AGENDA
REGULAR MEETING OF THE BIRMINGHAM PLANNING BOARD
WEDNESDAY JANUARY 25, 2023 – 7:30 PM
151 MARTIN ST., CITY COMMISSION ROOM 205, BIRMINGHAM MI*

- E.** Unfinished Business
- F.** Rezoning Applications
- G.** Community Impact Studies
- H.** Special Land Use Permits
 - 1. **34350 Woodward – Fred Lavery Porsche – Request for Special Land Use Permit for New 3-Story Auto Sales Agency**

- 2. **479 S. Old Woodward – Birmingham Tower – Request for Special Land Use Permit for New 5-Story Mixed-Use Building.**
- I.** Site Plan & Design Reviews

SUBJECT: 34350 Woodward & 909-911 Haynes Street - Fred Lavery Porsche – SLUP Amendment and Final Site Plan and Design Review

SHEET TITLE
EXTERIOR LIGHTING CALCULATIONS

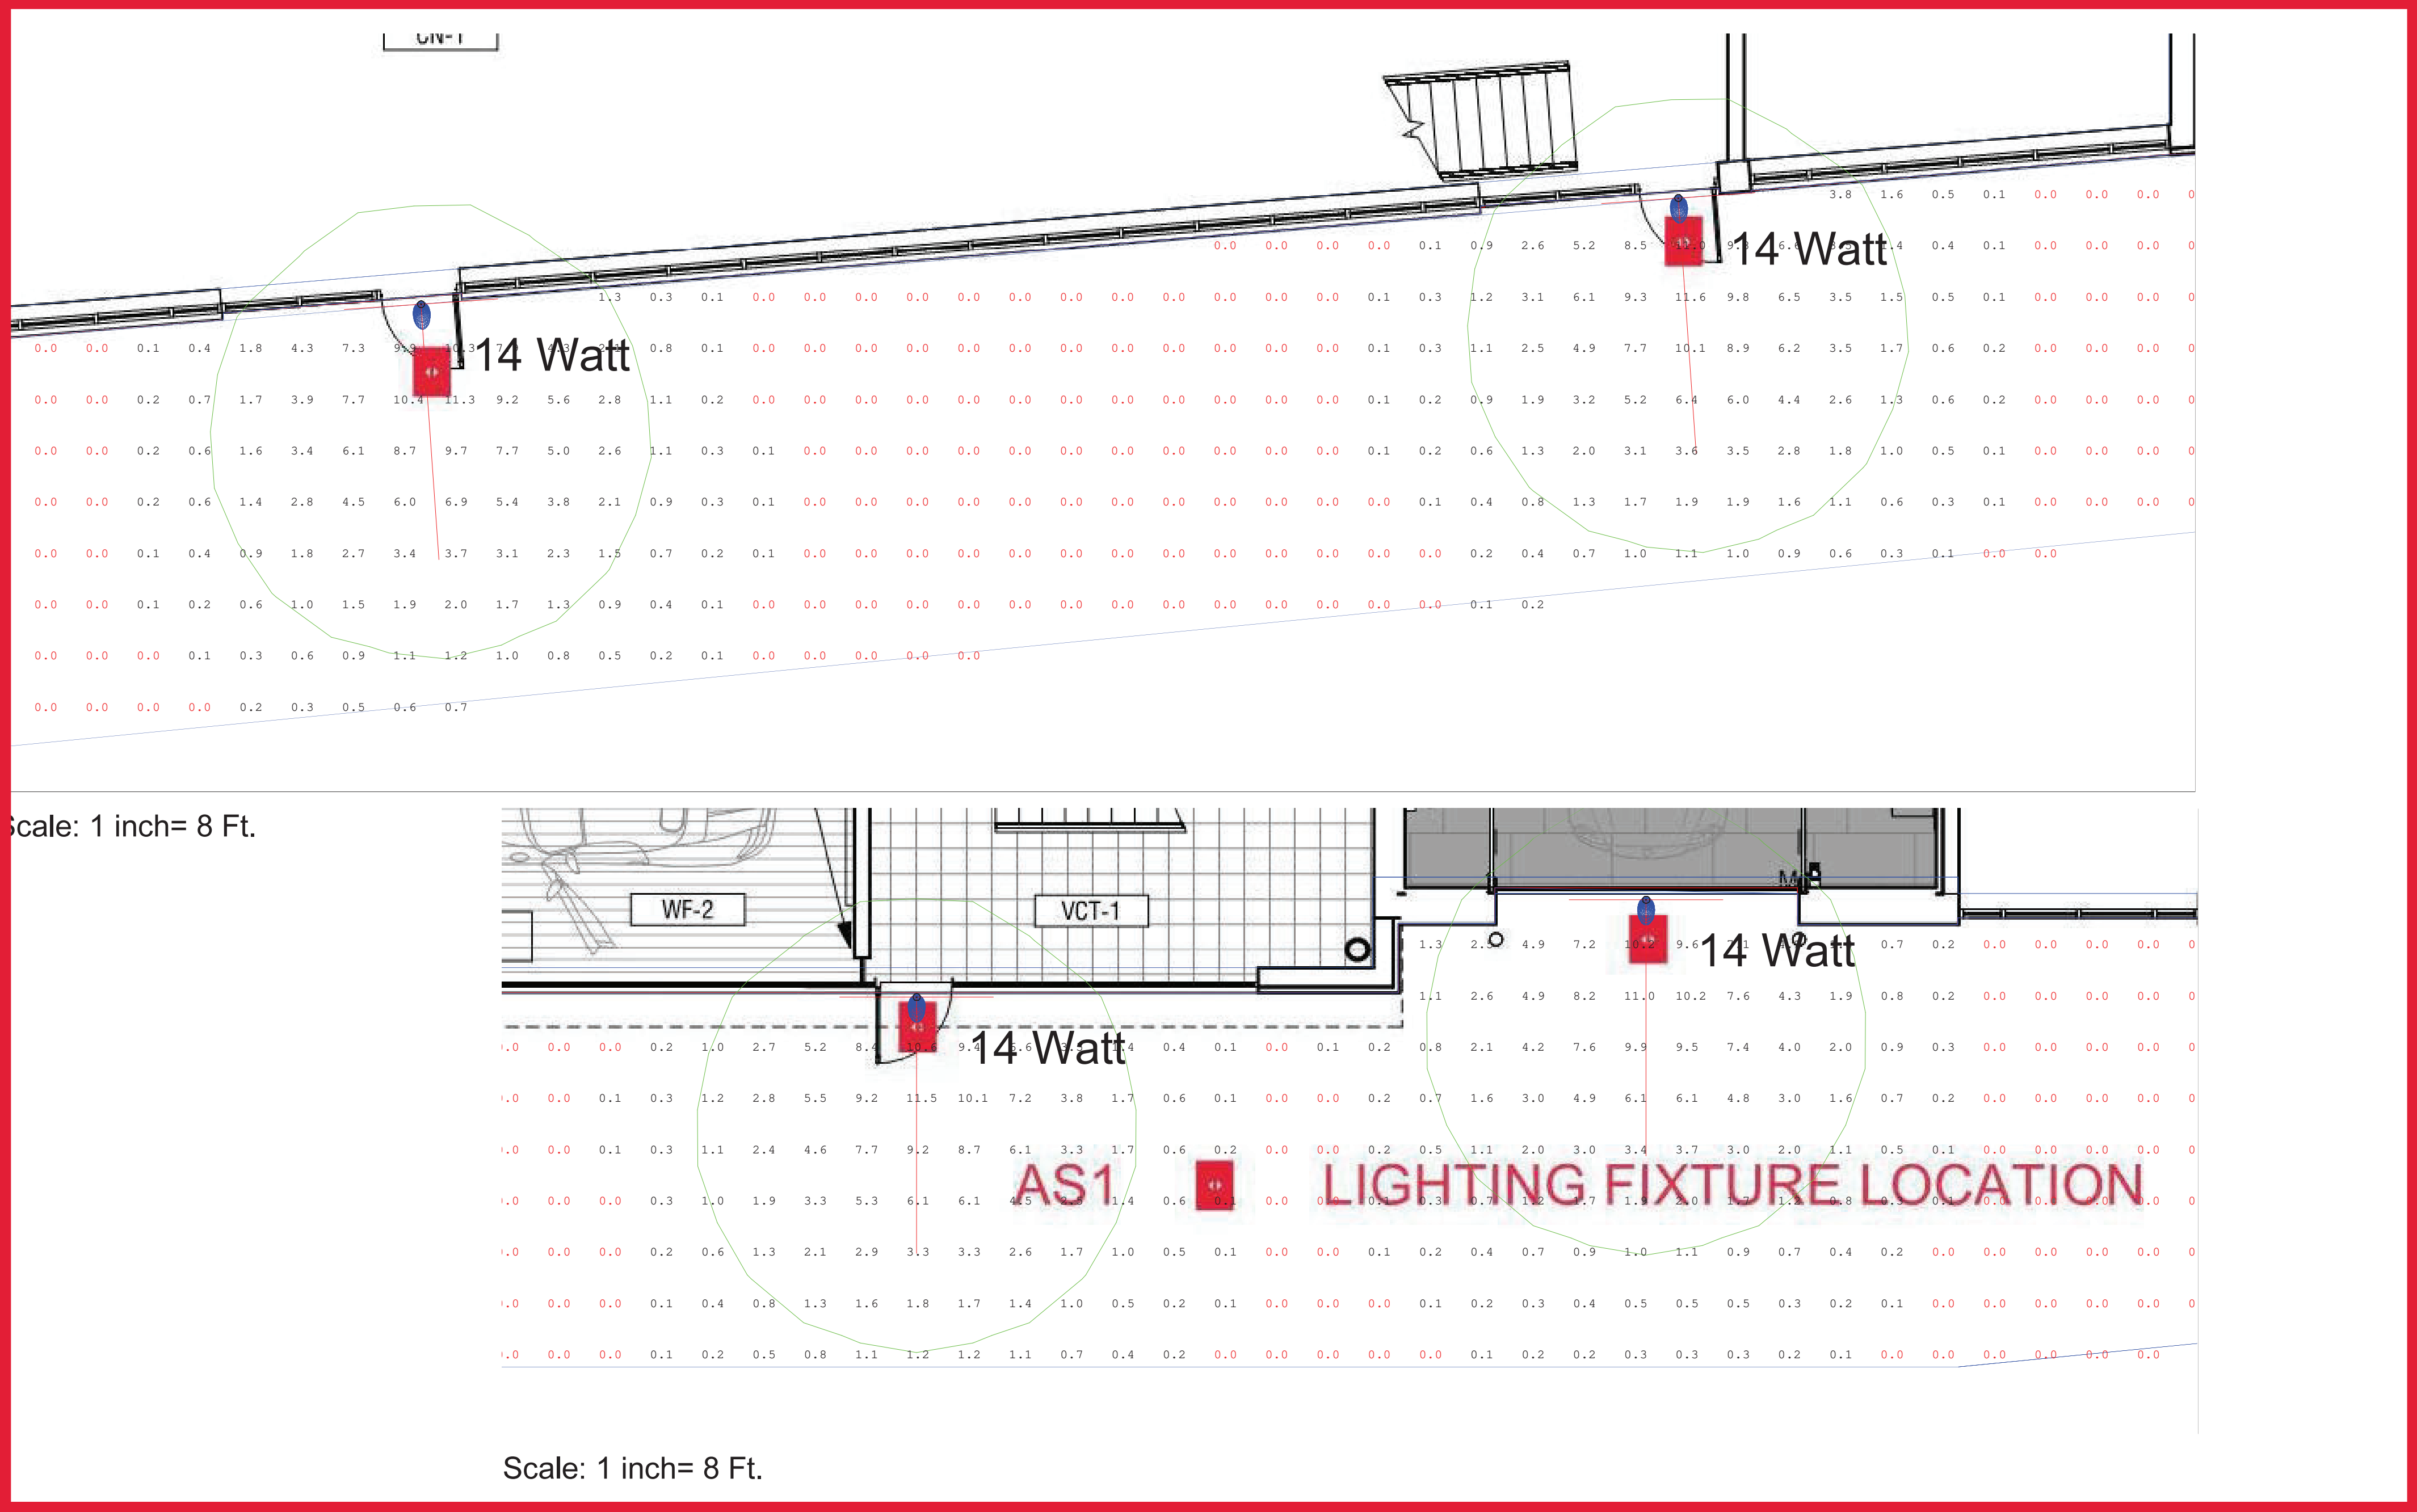
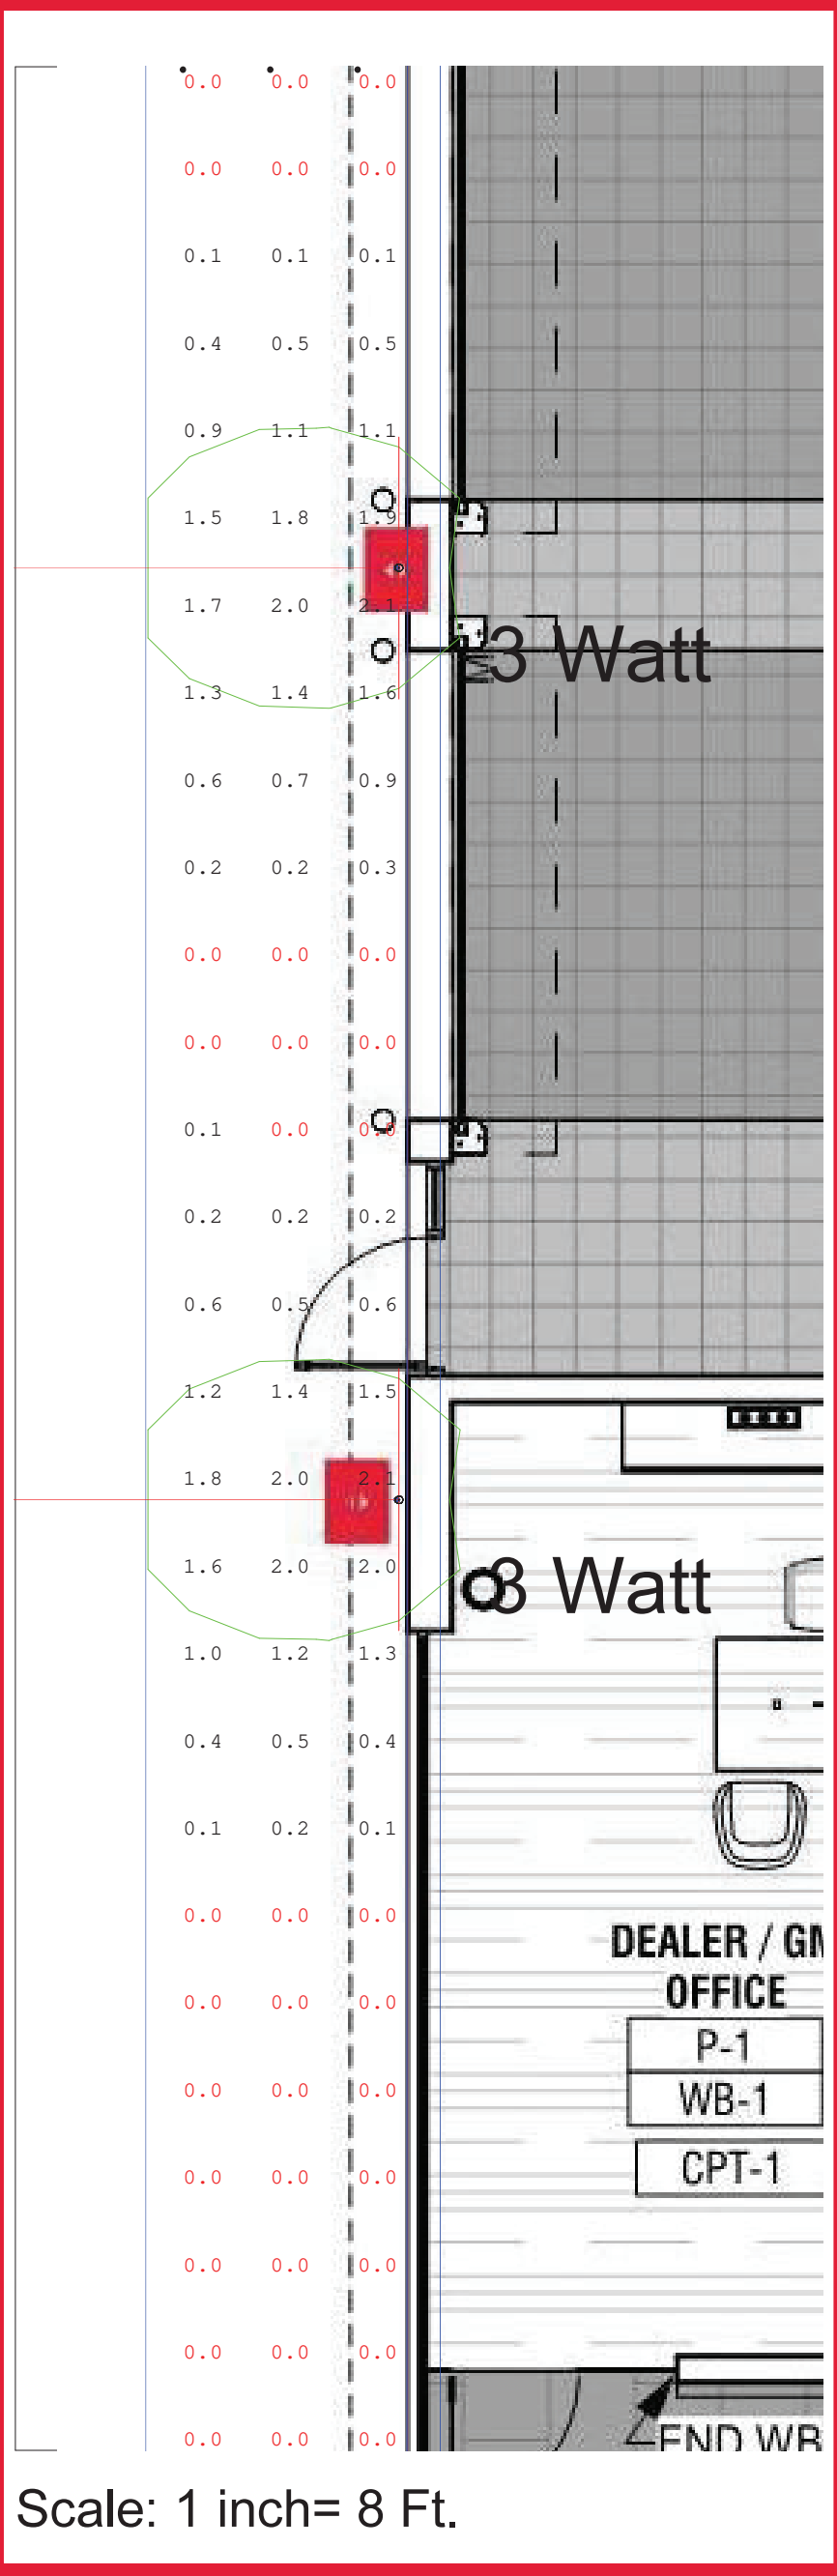
The applicant is proposing twelve exterior light fixtures. Eight lights are proposed to face the street frontage of Elm and Haynes Street, two exterior lights will face the eastern parking lot, and one exterior light is proposed in the exterior. The exterior light fixtures pictured on the elevations labeled AS-1 appear to be cut-off fixtures and are labeled as Bega exterior lighting fixtures, however the plans do not appear to provide a detailed specification sheet regarding the type of light fixture. Information such as the watts and lumens have been provided though. **The applicant must provide staff specifications of the exterior lights to verify they are cut off fixtures.**

The applicant has also provided a detailed photometric plan of the site. The lumens do not exceed 1.5 foot candles at any property line. **City staff request that the applicant update the photometric plan to provide a table showing the range of lumen values for the parking circulation area on the east side of the building to verify the lighting requirements for parking lot circulation areas have been met.**

4. The applicant provide updating lighting information regarding the light fixture specifications and the parking lot circulation area lumen values;
5. The Planning Board approve deviations to the architectural requirements of of Section 3.09(D)(1), Section 3.09(B)(2), and Section 3.09(A)(4) to enable the applicant creativity and flexibility in design for a metal exterior, a non-inset front door, and a garage door on the front façade with the condition that the applicant provide a front elevation drawing of the proposed building superimposed on a color drawing or photograph of the entire block showing the relation of the proposed building design to other buildings along the block; and
